UNITED STATES PATENT AND TRADEMARK OFFICE

APPLICATION NO.	FILING DATE	FIRST NAMED INVENTOR	ATTORNEY DOCKET NO.	CONFIRMATION NO.
10/025,902	12/26/2001	Hong-Man Moon	8733.559.00	7628

Office Action Summary

DETAILED ACTION

FIG. 3

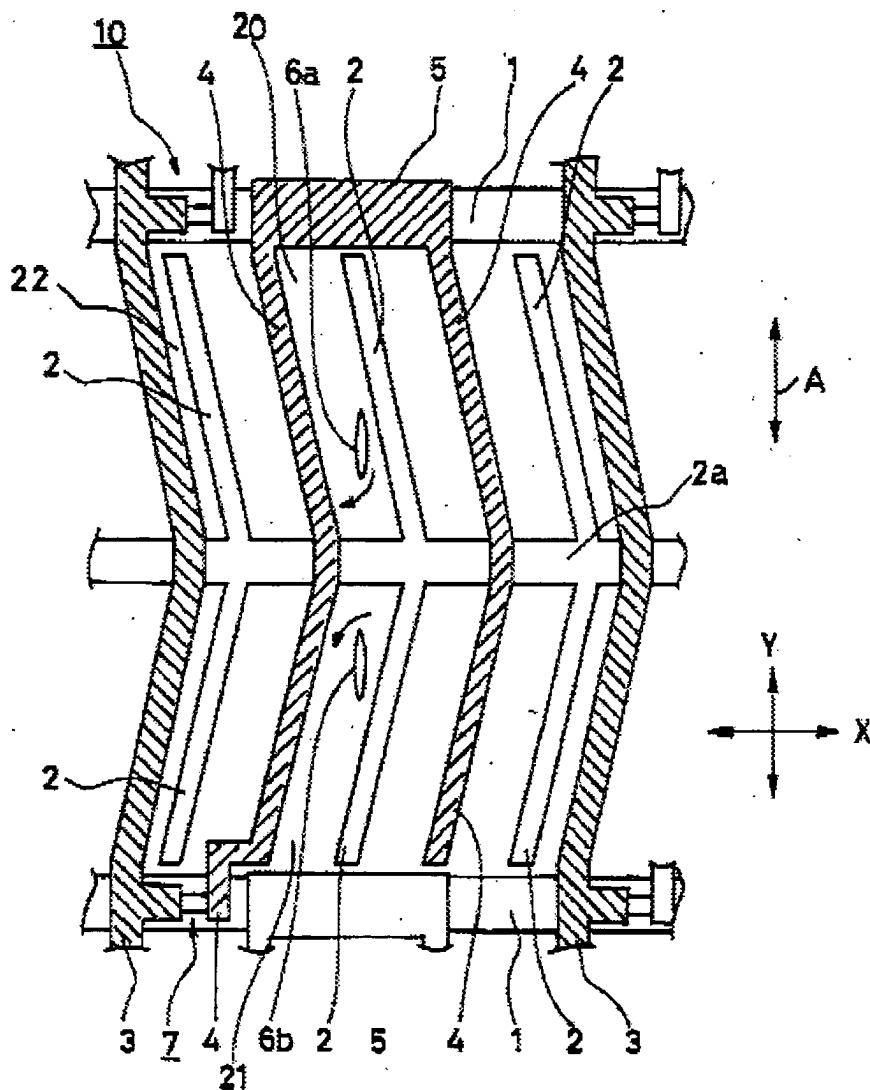
As to claim 1, Asada discloses in Figure 3, second embodiment, (col. 6, line 55 through col. 7, line 5) that is a variation of the first embodiment (col. 4, line 58 through col. 6, line 54) an in-plane switching liquid crystal display device, comprising:

- first and second substrates;
- a scanning wiring, 1 (Applicant's gate line), and a signal wiring, 3 (Applicant's data line), defining a pixel region on the first substrate;
- a common line, 2a, on the middle of the pixel region;
- a thin film transistor, 7, at a crossing portion of the gate and data lines, the thin film transistor having gate, source, and drain electrodes;
- a first insulating layer on the gate line;
- a plurality of transparent common electrodes, 2 (center electrodes, top and bottom), on the first substrate;
- a plurality of transparent pixel electrodes, 4 (right electrodes, top and bottom), on the first substrate;

at least one extended portion, 2 (common electrodes on left and right, top and bottom, near data lines) extending from the common line at a boundary of the pixel region, and

As to claim 2, Asada discloses the device of claim 1, wherein the common electrode is connected to the common line per center of Figure 3.

As to claim 7, Asada discloses the device of claim 1, wherein the pixel region is divided by the common line per Figure 3.

As to claim 8, Asada discloses the device of claim 1, further comprising an overlap (vertical portions of pixel electrodes) of the pixel electrodes over the common line (Applicant's first storage electrode on the first insulating layer over the common line) per Figure 3.

As to claim 9, Asada discloses the device of claim 8, wherein said first storage electrode is connected to the switching device, 7 (Applicant's drain electrode), per Figure 3.

As to claim 10, Asada discloses the device of claim 1, further comprising capacitive accumulation portions, 5 (Applicant's second storage electrode) on the first insulating layer over the gate line per Figure 3.

As to claim 11, Asada discloses the device of claim 10, wherein the second storage electrode, 5, is connected to the pixel electrode, 4, per Figure 3.

As to claim 13, Asada discloses the device of claim 1, wherein the extended portion is substantially perpendicular to the common line (runs generally up and down rather than left to right in Figure 3).

As to claim 16, Asada discloses the device of claim 14, further comprising an overlap (vertical portions of pixel electrodes) of the pixel electrodes over the common line (Applicant's first storage electrode on the first insulating layer) per Figure 3.

As to claim 17, Asada discloses the device of claim 16, wherein said first storage electrode is over the common line per Figure 3.

FIG. 4

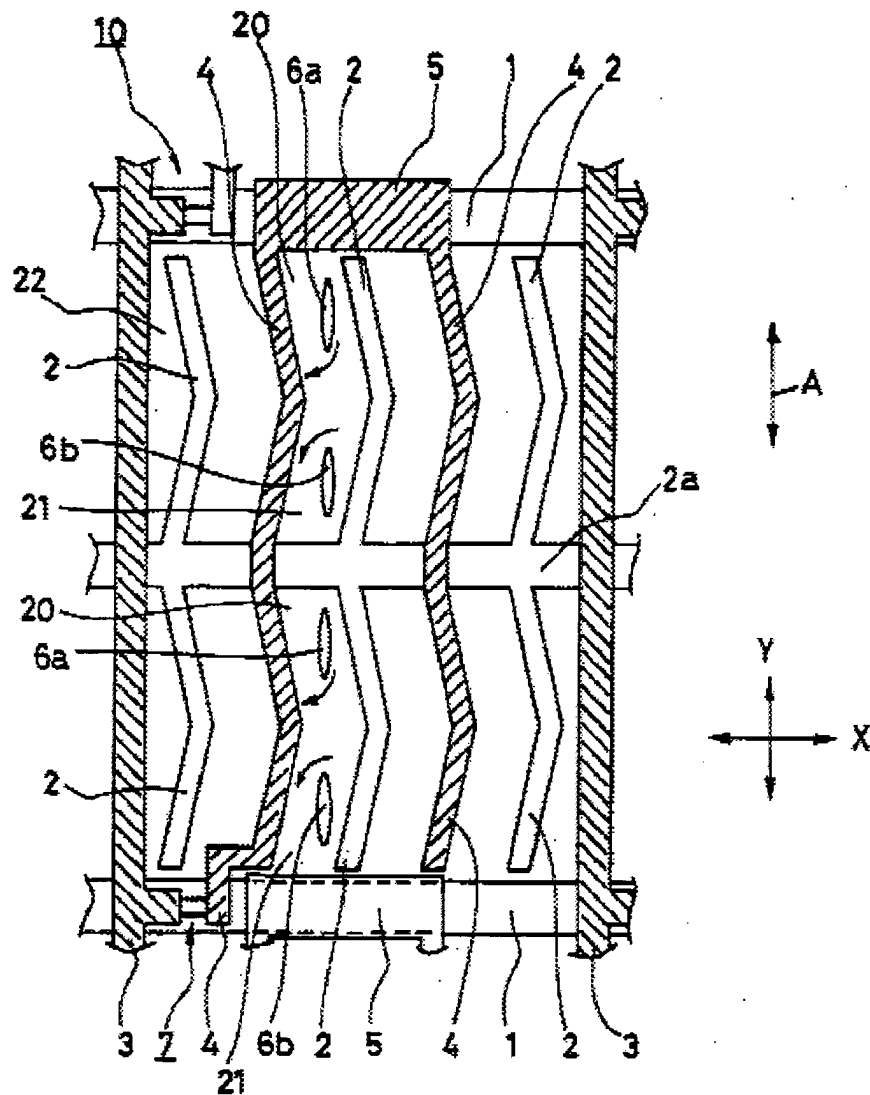
Asada teaches in embodiment 3 (Figure 4) a device wherein the common electrode, 2, has a substantially zigzag shape in order to improve aperture ratio (col. 7, lines 5-35).

Asada teaches in embodiment 3 (Figure 4) a device wherein the pixel electrode, 4, has a substantially zigzag shape in order to improve aperture ratio (col. 7, lines 5-35).

FIG. 20

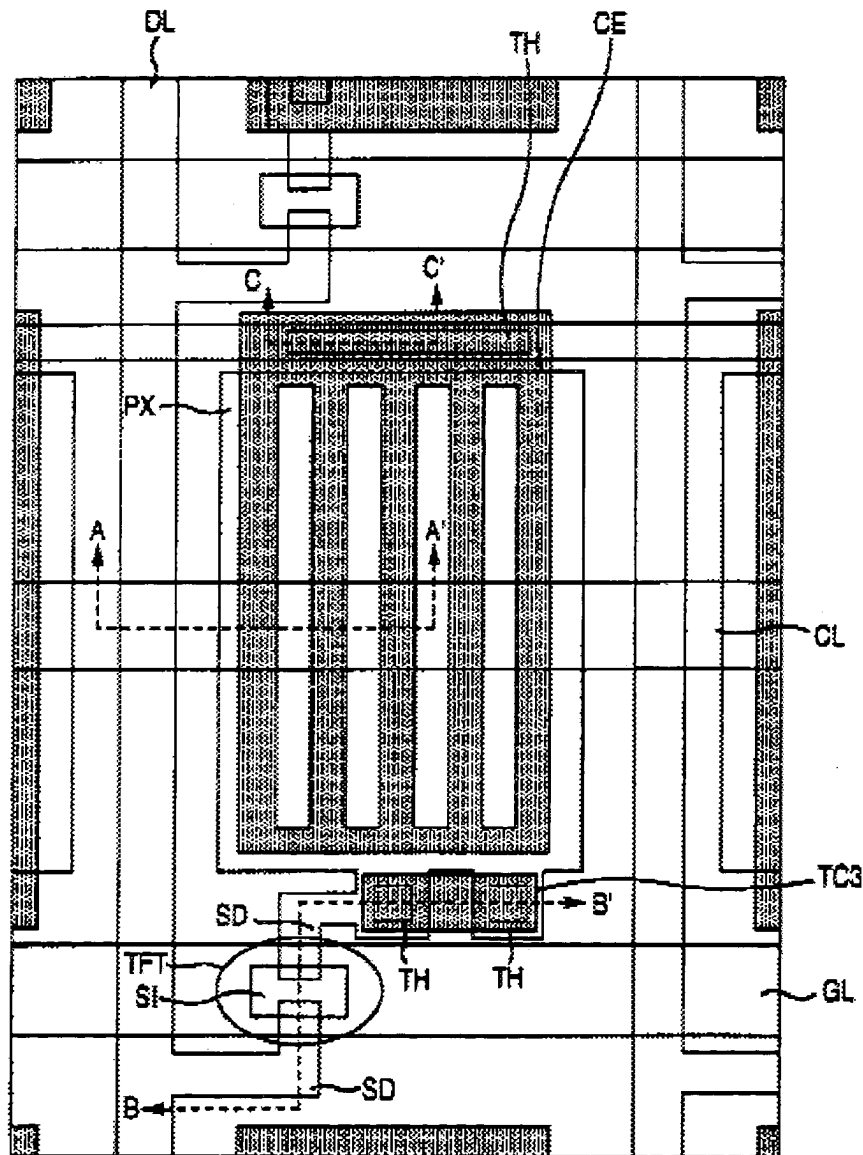
Abe teaches in his third embodiment, Figures 20 and 22, (col. 30, lines 1-65) the use of a transverse common electrode (left to right portion of CE) over the common line wherein the transverse common electrode contacts the common line through at least one contact hole (TH) in his design to reduce required driving voltage.

Abe is evidence that ordinary workers in the art of liquid crystals would find the reason, suggestion, or motivation to add a transverse common electrode over the common line wherein the transverse common electrode contacts the common line through at least one contact hole in his design to reduce required driving voltage.
